Well Name: CORRAL BLUFF 11_14 FEDERAL COM	Well Location: T25S / R29E / SEC 11 / NENE /	County or Parish/State:
Well Number: 36H	Type of Well: OIL WELL	Allottee or Tribe Name:
Lease Number: NMNM15303	Unit or CA Name:	Unit or CA Number:
US Well Number: 3001548024	Well Status: Approved Application for Permit to Drill	Operator: OXY USA INCORPORATED

Notice of Intent

Sundry ID: 2713573

Type of Submission: Notice of Intent	Type of Action: APD Change
Date Sundry Submitted: 02/01/2023	Time Sundry Submitted: 10:31
Date proposed operation will begin: 05/01/2023

WELL LOCATION AND ACREAGE DEDICATION PLAT

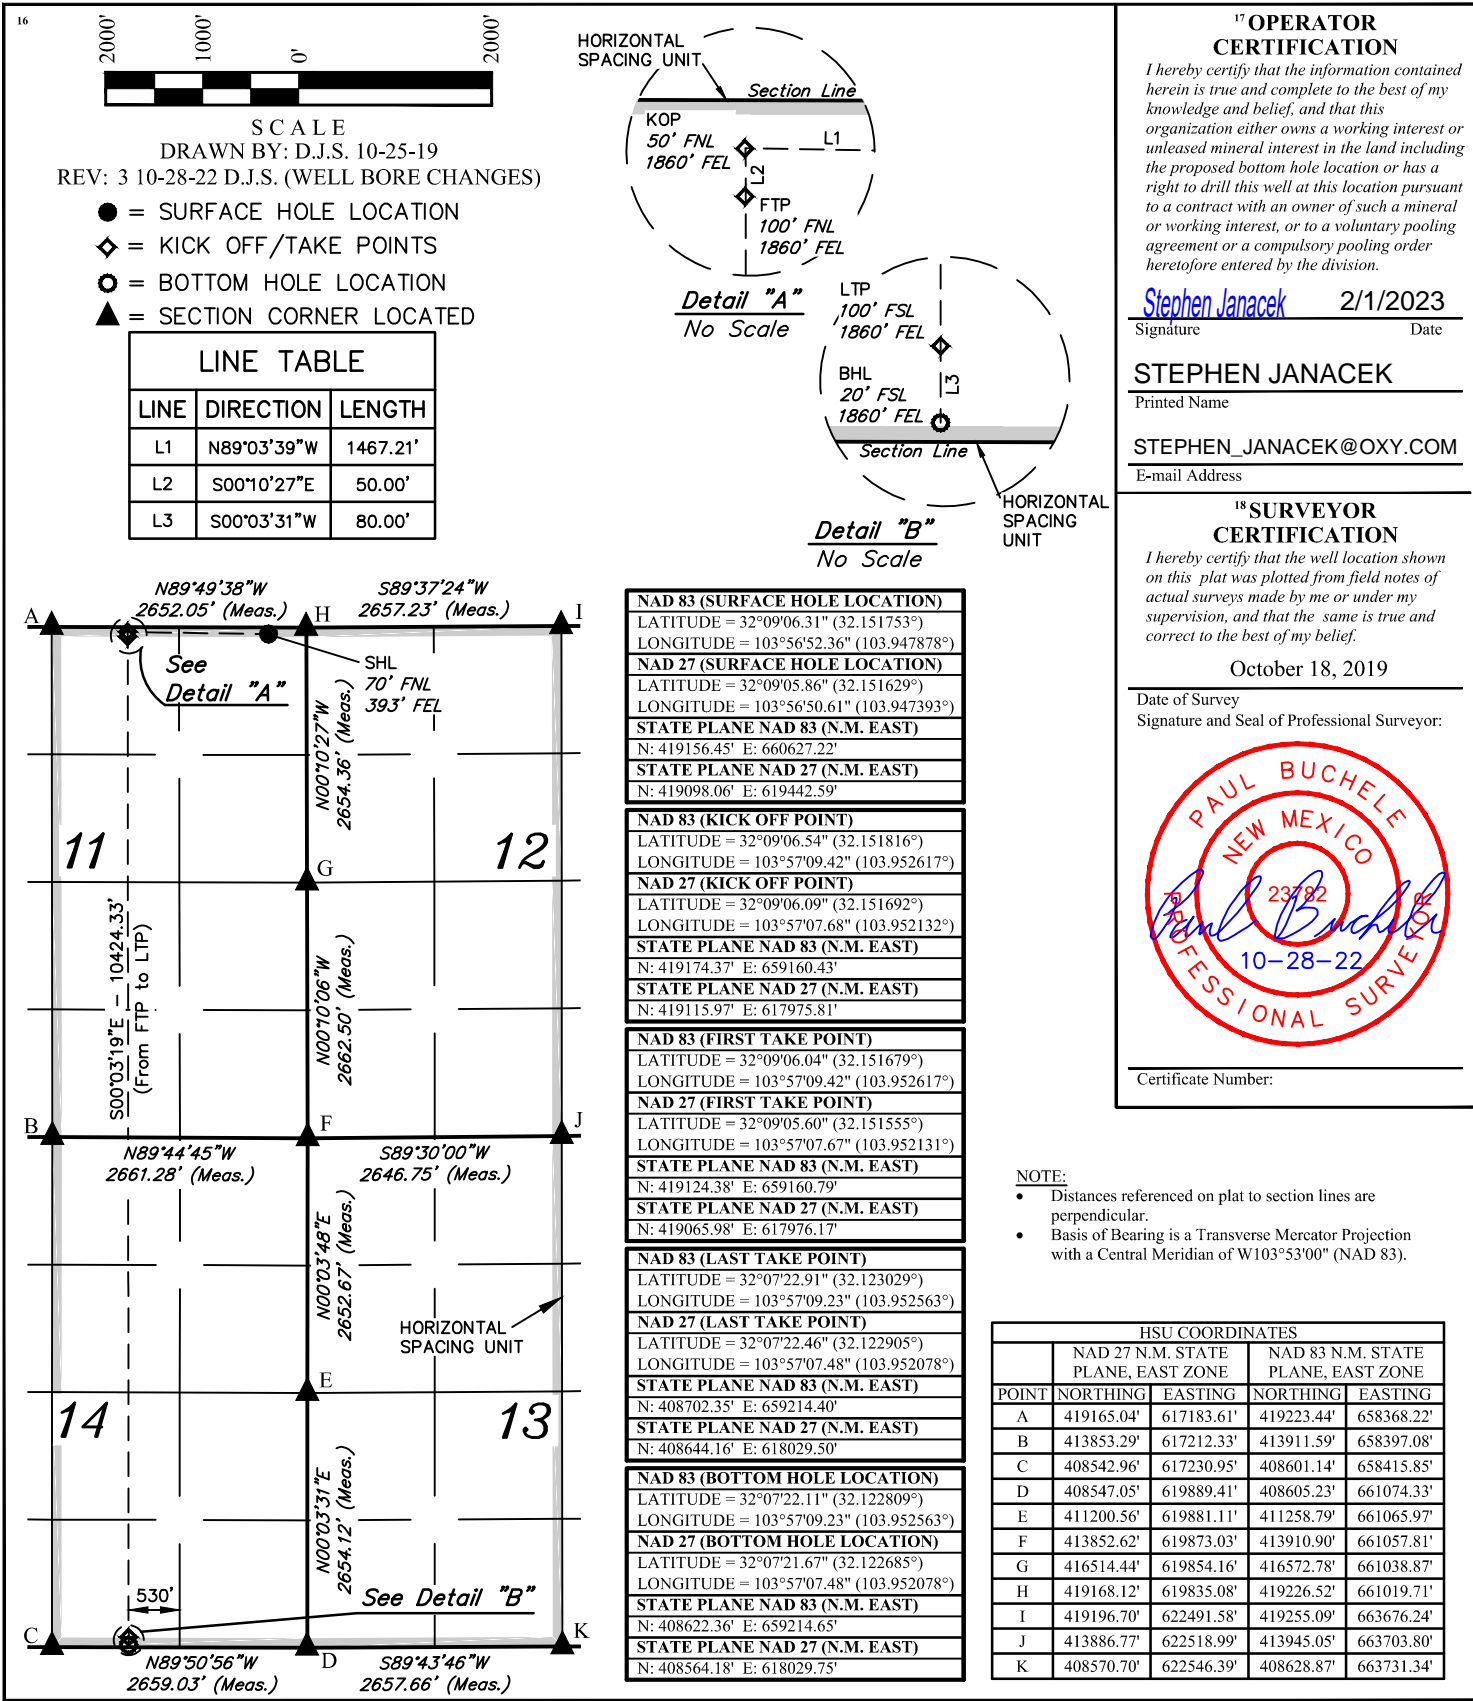
Procedure Description: The new drill plan and C-102 are attached. The old BHL was 20 FSL, 1700 FEL, Sec 14, T25S, R29E. The new BHL is 20 FSL, 1860 FEL, Sec 14, T25S, R29E.

UL or lot no. O	Section 14	Township 25S	Range 29E	Lot Idn	Feet from the 20	North/South line SOUTH	Feet from the 1860	East/West line EAST	County EDDY
¹² Dedicated Acres 1280	¹³ Joint or Infill Y	¹⁴ Consolidation Code	¹⁵ Order No.
